File no. PM00301.04

Hume Highway upgrade. Woomargama bypass (MP 08_0237). Modification request for Mountain Creek Bridge flooding impacts.

Letter dated 11 April 2011 from the Environment & Sustainability Manager – HHWA

Figure 1 – Change in flood levels for detailed design of 4 span bridges

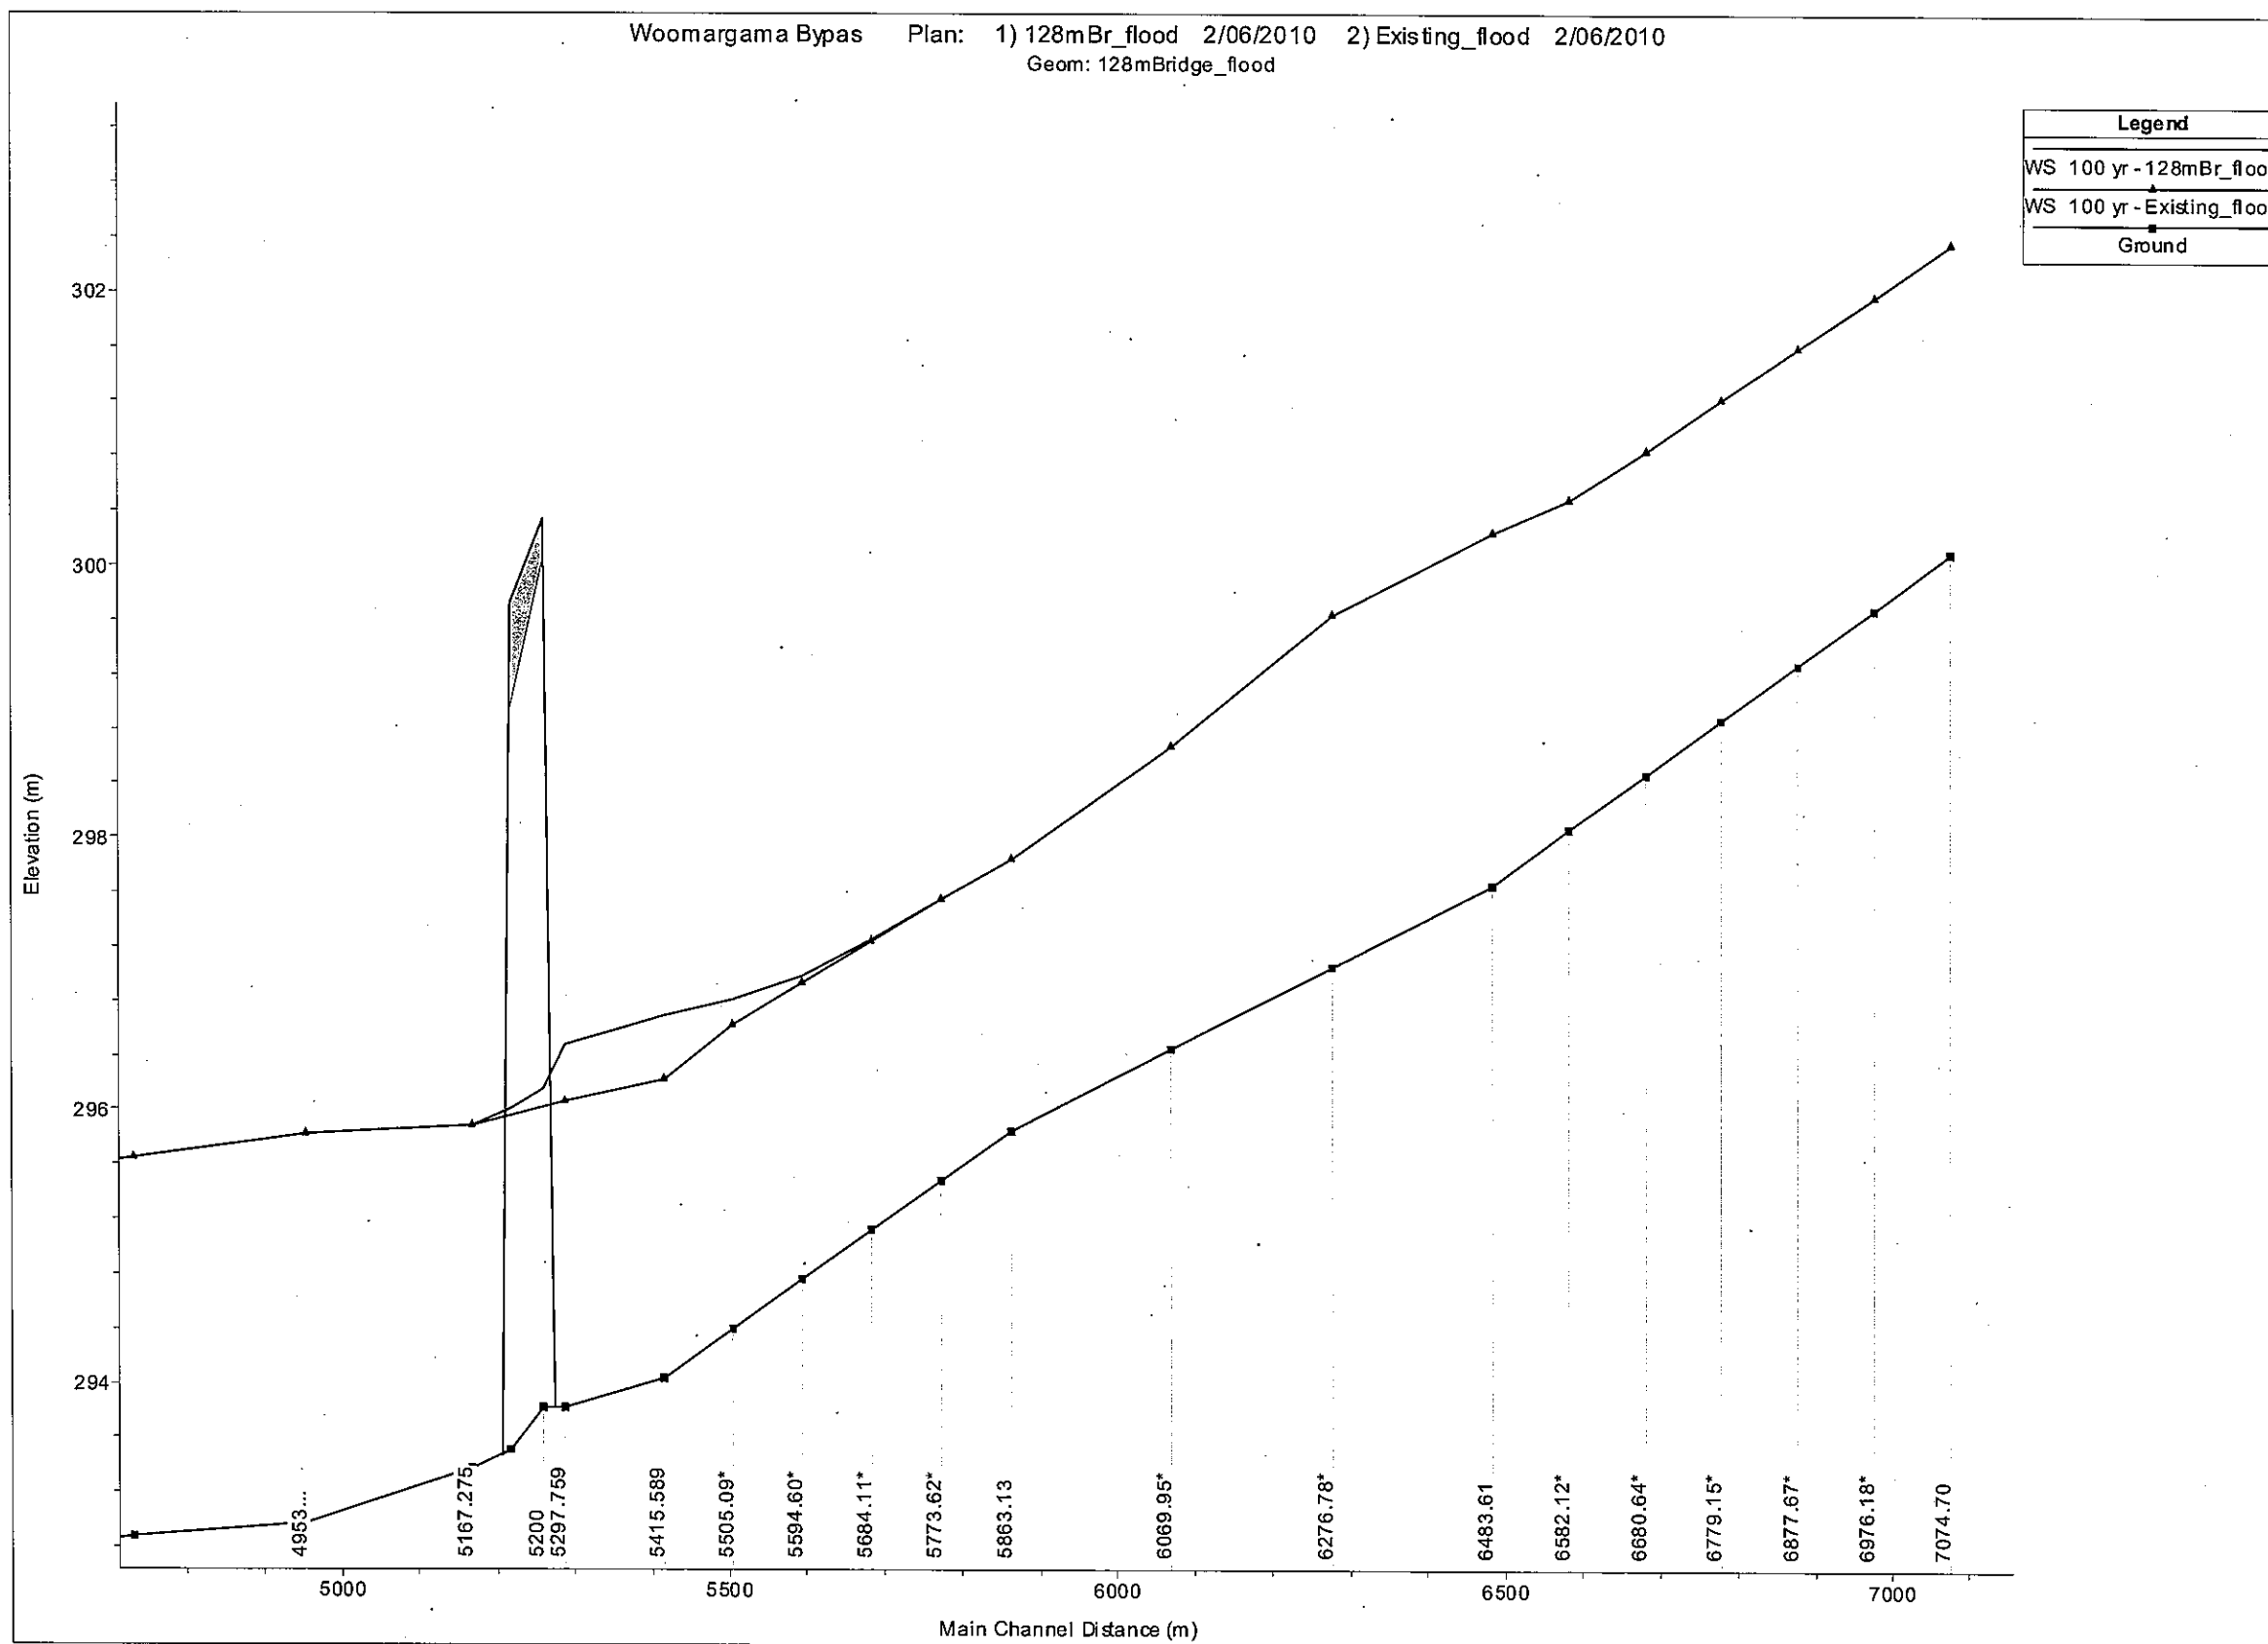
Also attached to this letter are a creek long section and creek cross sections at various chainages upstream of the bridges showing changes in flood levels, together with a completed request to modify a major project application form.
